Subject: Revised manuscript with the reference number: nhess-2021-351

We would like to thank you for giving us an opportunity to revise our manuscript. We have addressed all the concerns comments and would like to submit our revised manuscript entitled " **Probabilistic Fault Displacement Hazard Analysis for North Tabriz Fault**" for further consideration. We have modified the manuscript thoroughly by considering all of the comments raised by the reviewers and editor which indeed improved the manuscript. In the following we respond to the comments in details.

Figure 9. Comparison of drop in displacement values in scenarios, a) 50years, b) 475years, c) 2475years

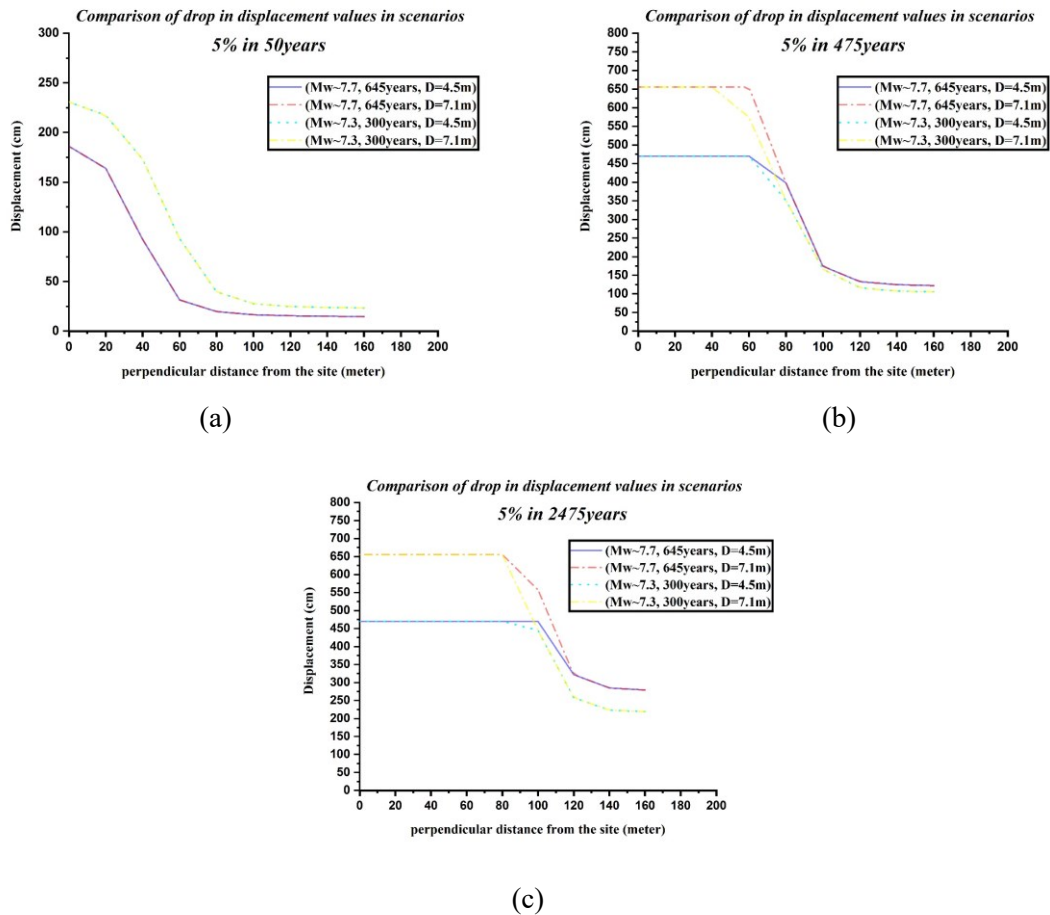
- 4) The section Results and Discussions is very poor. There is no discussion about the results and, for me, it has been very hard to understand how input parameters are considered and which equations are used. This paper could help the seismic hazard local community but it needs a major review in order to make the manuscript clear and readable. Reading the paper I have the feeling that most of things are omitted and not well described.

To explain the results obtained more clearly, we added Figure 9 which examines and compares the results obtained for two different scenarios and identifies the worst case and will have a better description of the results obtained. Please see the "Results and Discussions" of the annotated manuscript.
